Map - confirmation

Marcia Renert 580 Oak Summit Rd. Millbrook, N.Y. 10021
Florida Concepts Pools Inc.

Latham Lakeshore one piece inground Fiberglass Pool

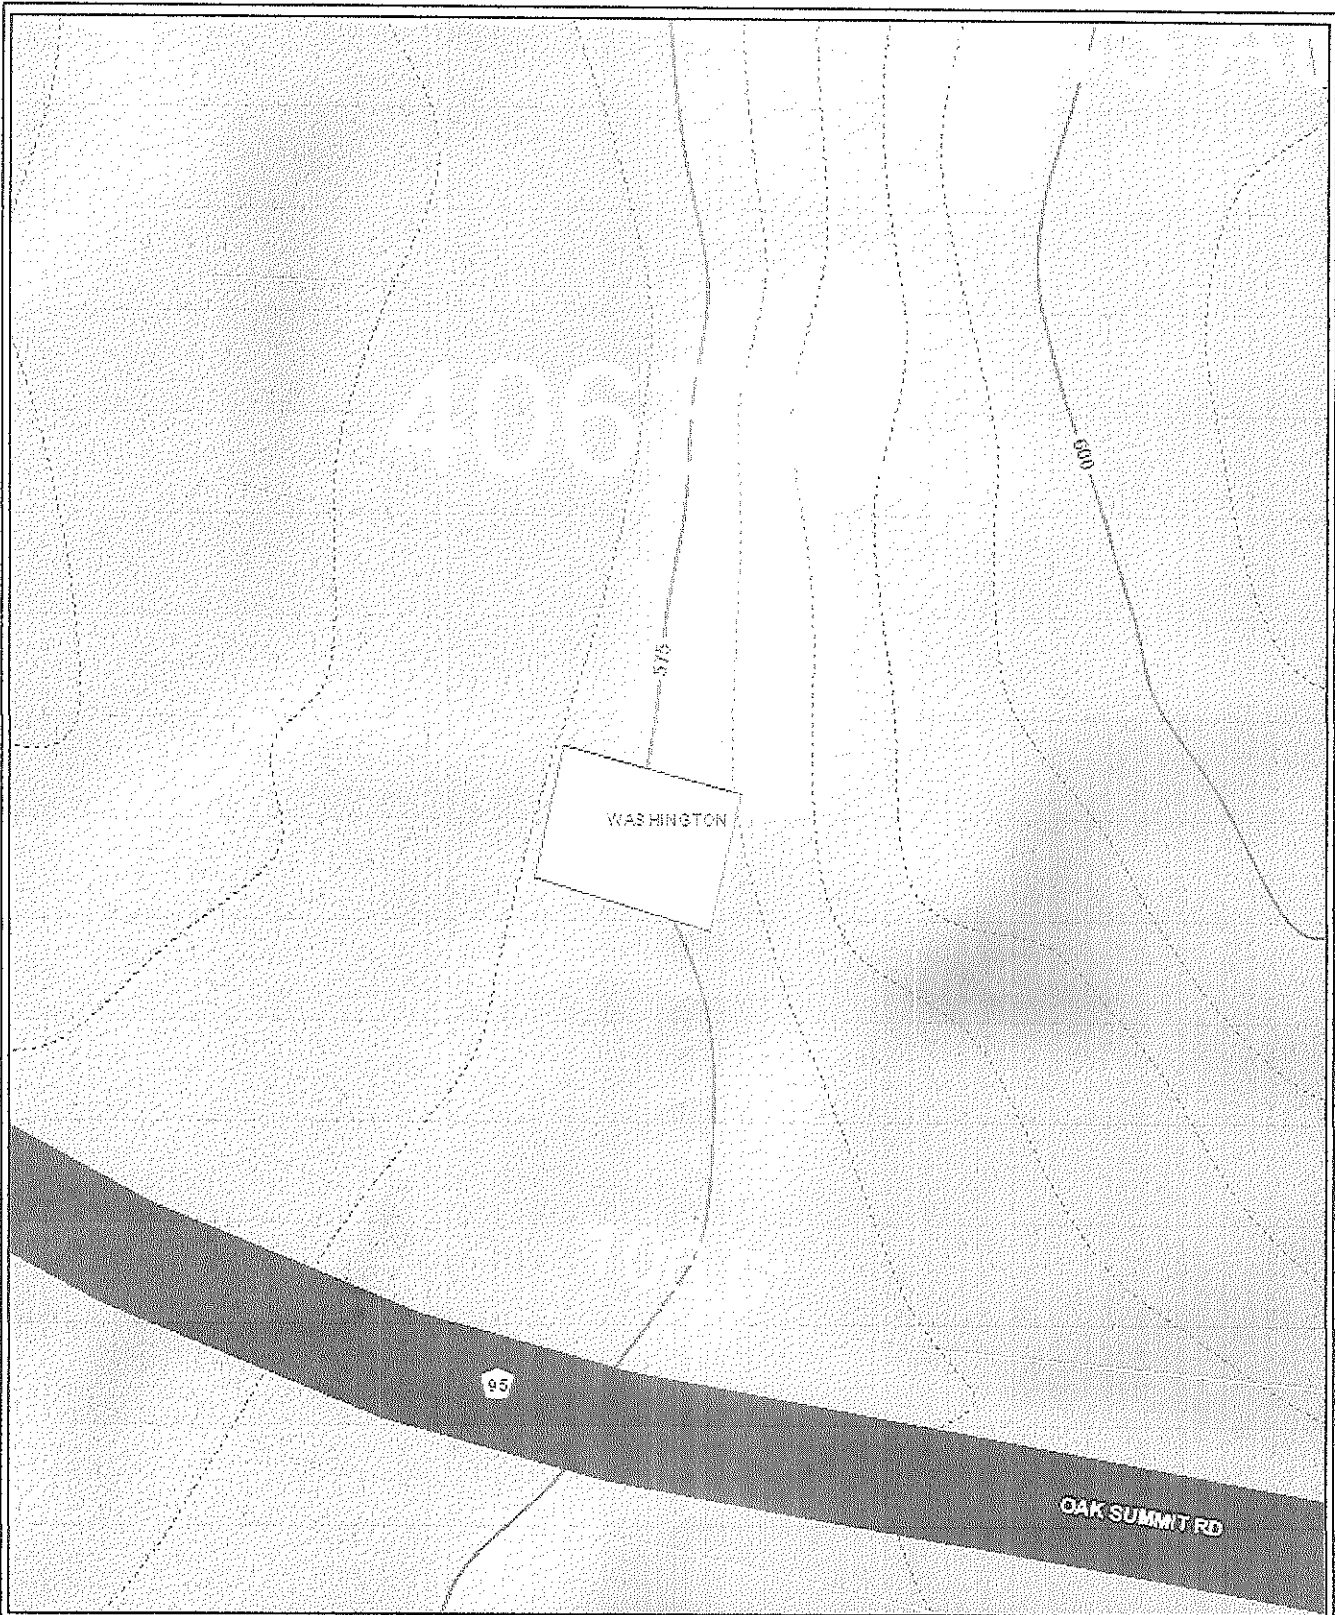
Hi Marcia. I have reviewed the survey you sent and will confirm that the pool itself is outside of the buffer zone. Unfortunately this still doesn't answer all the questions that we've talked about in the past. Below is my summary of the rules as they apply to your project from my email dated July 14, 2021:

"Without seeing a complete plan of what you are proposing it is impossible to say if there will be an impact or not. How much grading and tree clearing is necessary? Where will the pool equipment go and how will power get to the pool? How and to where will the pool be drained if necessary? Where will the fence go? Will there be a pool house and/or patio area around the pool? It is certainly possible that there will be no impact, and if that is the case a permit would be issued. The problem is that without applying for a permit and showing plans of what is proposed it is not possible to make that determination. The permitting process is not intended to be a prohibition on doing anything within the buffer, but an opportunity to review what is being done to make sure that it doesn't impact the wetland function. I am copying Jim Finley on this email so that the Town can decide how it wants to proceed."

Maybe you can proceed with the variance discussion with the ZBA or maybe it's better to finalize the wetlands issues first before you go to the ZBA. The critical issue I see remaining is that there will be grading necessary to get a nice flat spot to put a pool/deck/fencing/equipment pad on the site. All you've shown so far is a flat map, and having seen the site I know that it is not flat. If you can get more info before the 19th I will be happy to look at it and update this review. If it's easier for you to understand I can come walk the site with you to better explain what is going on and what I need to see.

- 16x33 3.7'-5.5" Depth
- Pentair Cleaning Clear Plus Cartridge filter - No back washing
- 400,000 BTU Pentair MasterTemp gas heater

The cartridge filter does not require backwashing. Cartridges are removed, cleaned, and reused. Pool is not to be drained. Draining the pool would void warranty. Pool must be filled at all times to maintain the lifetime warranty. In the very unlikely event it would require a repair the water could be pumped into a water truck.
